Comments on #PSP-26-0004 - Planning & Zoning: Preliminary Subdivision Plat

Application Number: #PSP-26-0004
Application Type: Preliminary Subdivision Plat
Date: September 14, 2026
Address: 408 E YOUNG ST, ROLESVILLE, NC 27571
Parcel: 1768098727

Rolesville Town Campus

PRELIMINARY SUBDIVISION PLAT - SUBMITTAL #1

C-6.00

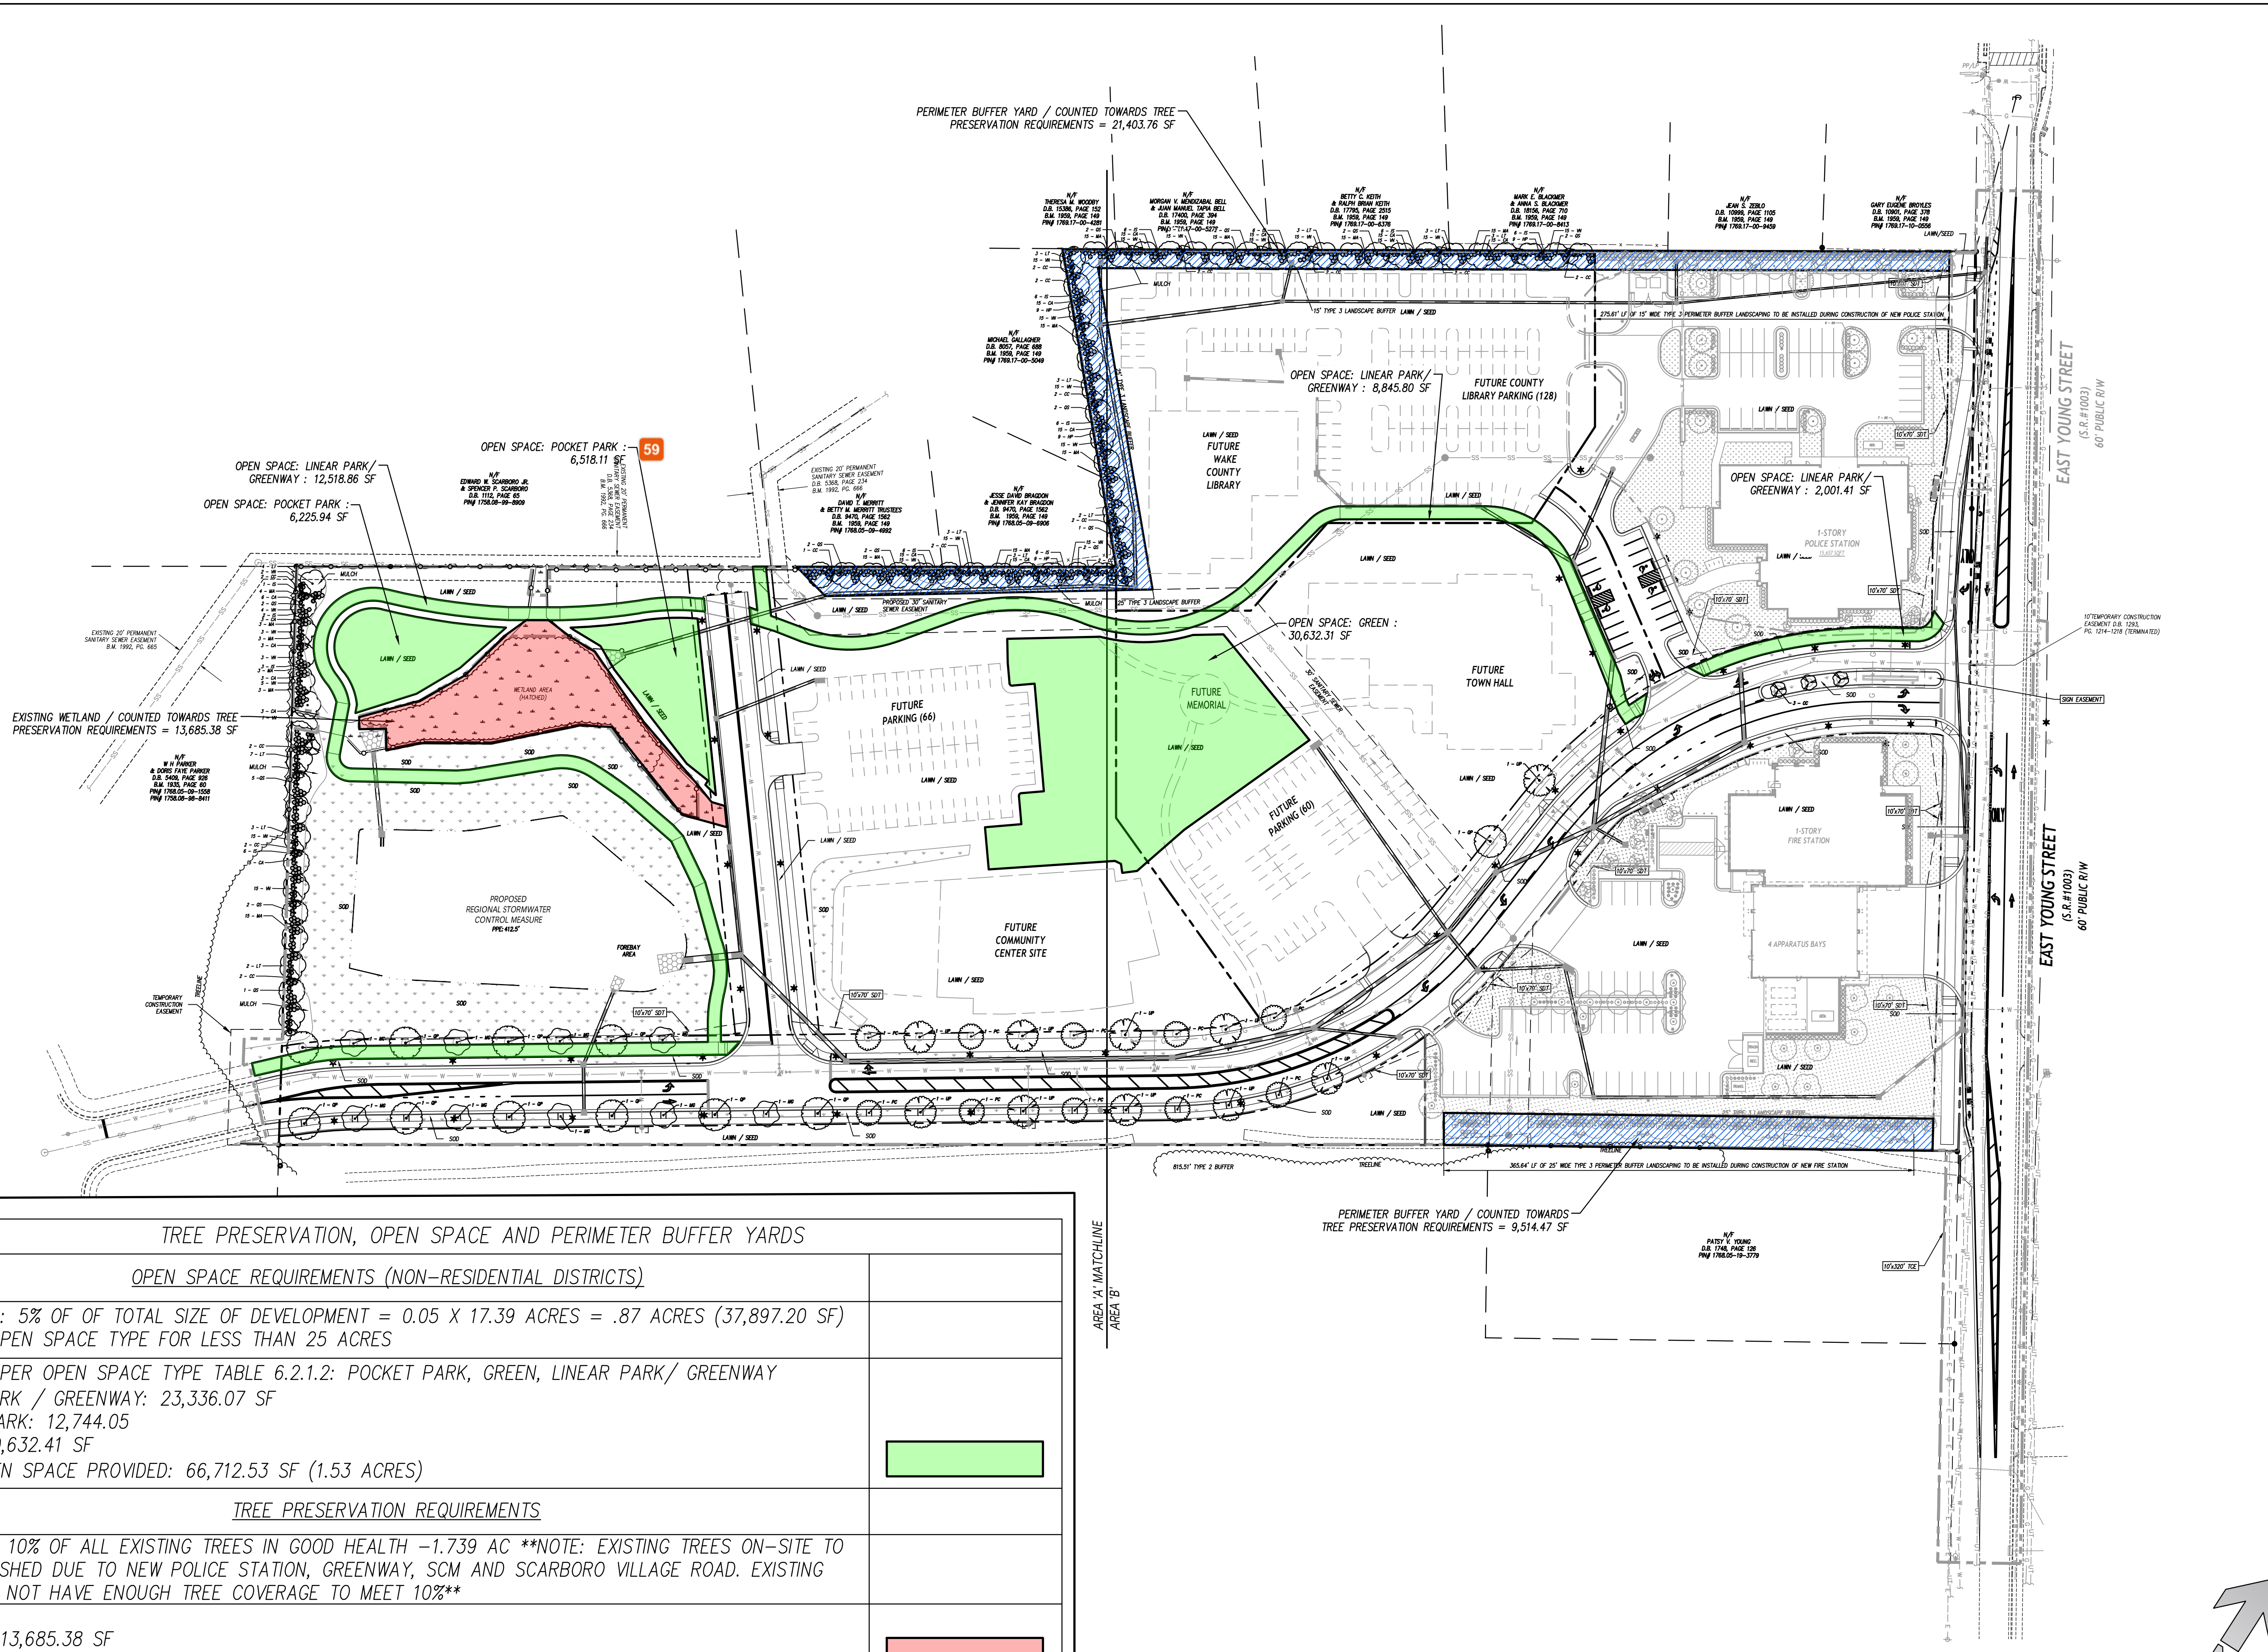
Landscape Plan and individual trees is CID level information Not PSP - remove but answer SW's question.

In subdivision, the Town has enforced not having trees between the curb and sidewalk, and has instead encouraged placement behind the sidewalks. According to the Standards Manual, the space between the curb and walk is to be left as a utility strip - not a planting strip.

C-6.01

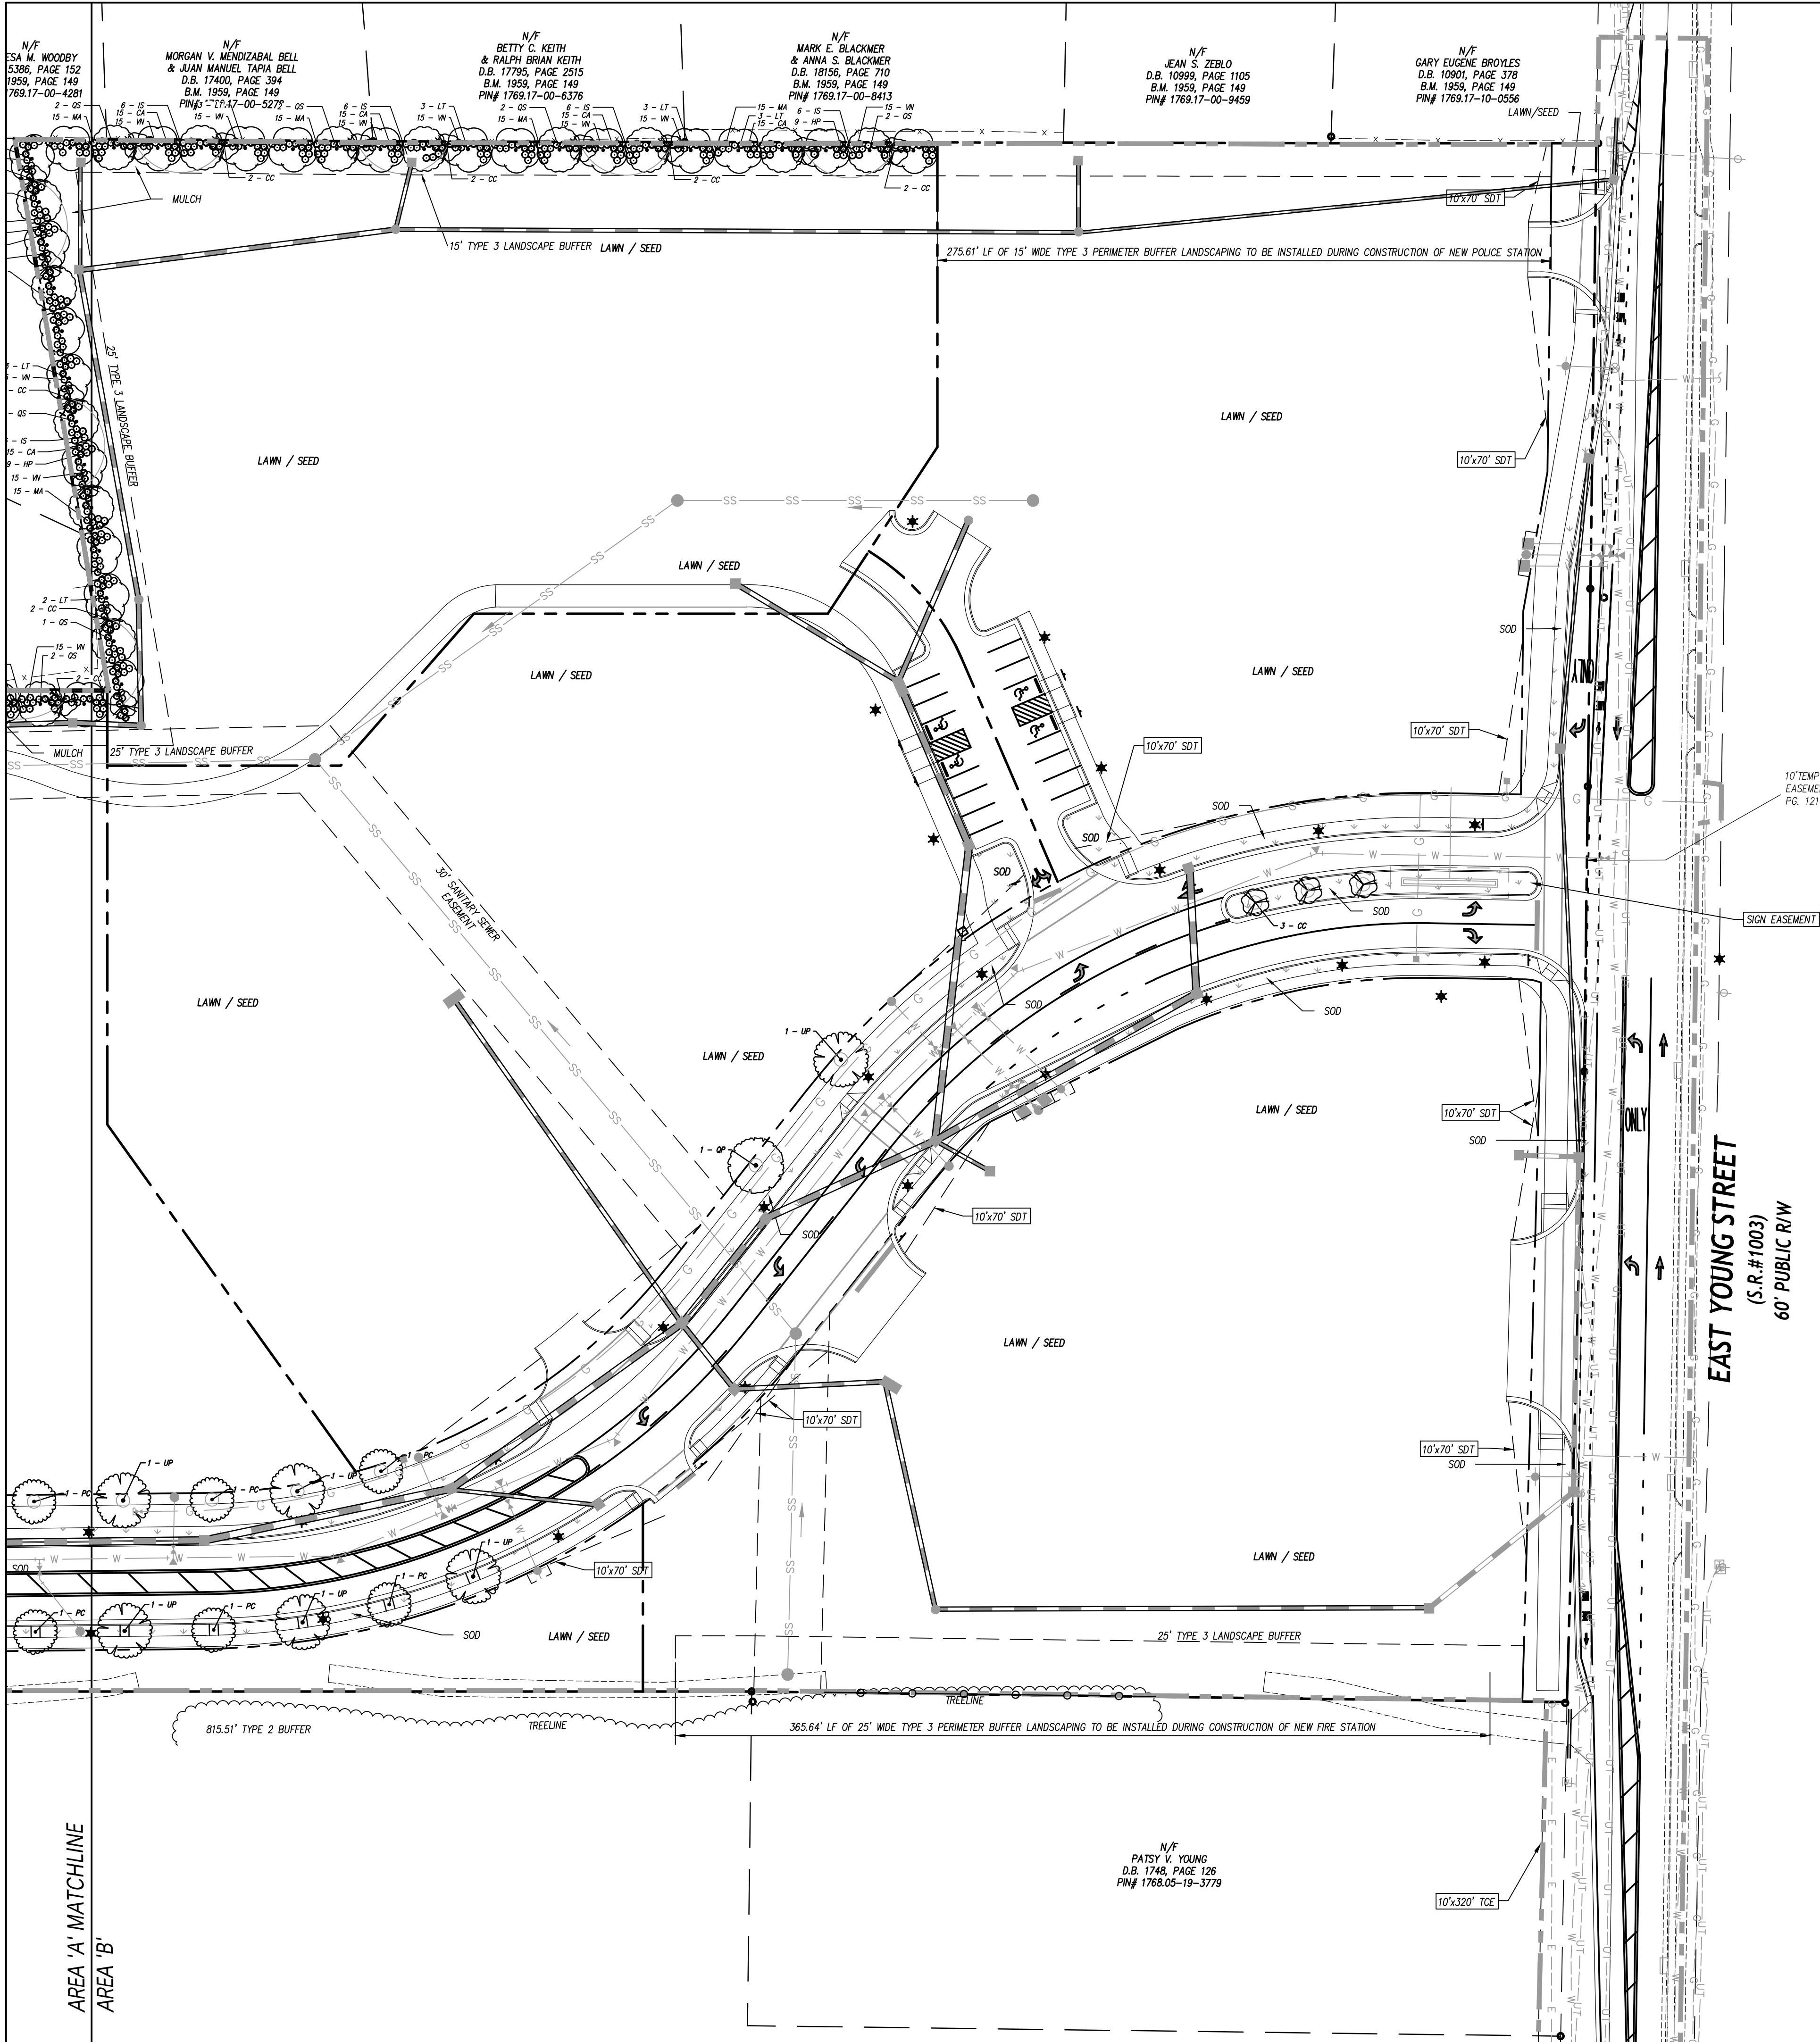
Please revise the landscape plan to remove *Ulmus parvifolia*, which is considered by the state to be an invasive – https://nc-ipc.weebly.com/uploads/6/8/4/6/6846349/invasive_plant_list_-_ranked_-_2023-11-16.pdf

Remove this sheet and next - landscaping is CID level information. The previous sheet, showing Tree Preservation AREAS and teh extents of LDO Open spaces and Perimeter and/or Street bufferyard AREAS, that is appropriate.

SHEET 1 OF 2

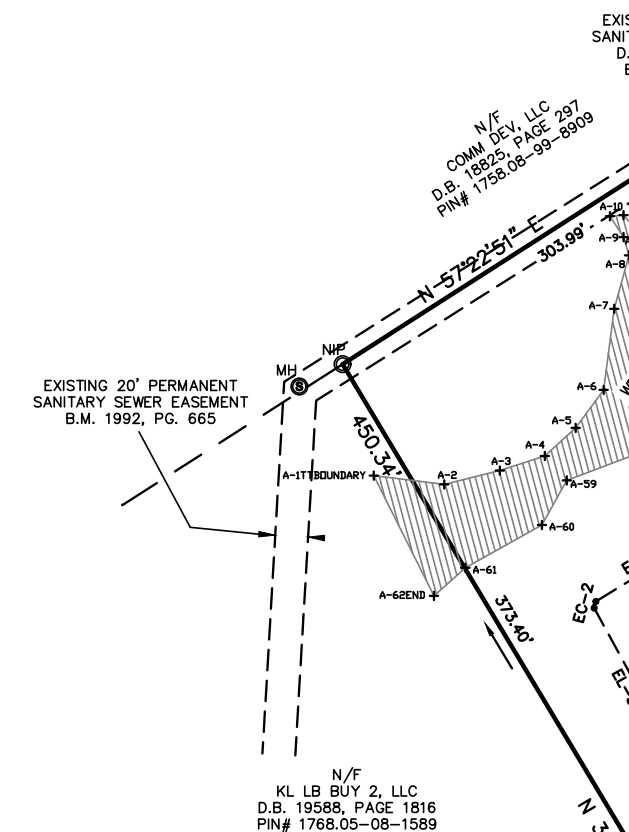
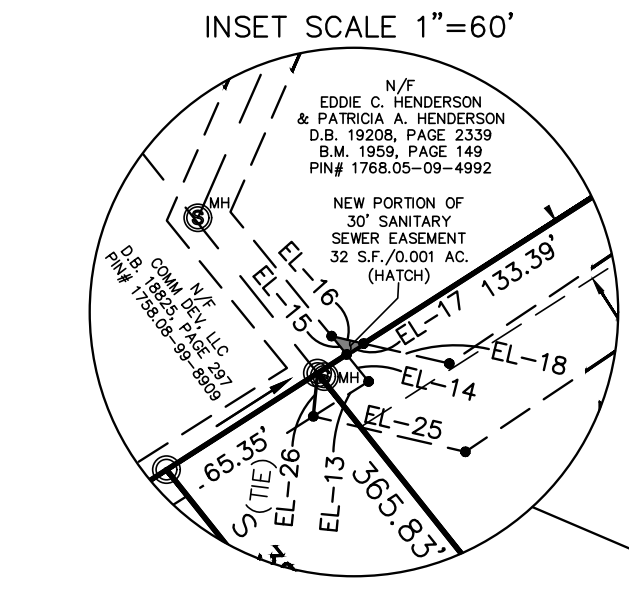
this is a Recordable Final PLat - remove, not appropriate within a PSP plan set.

On future FSP, show maximum impervious per lot in a table.
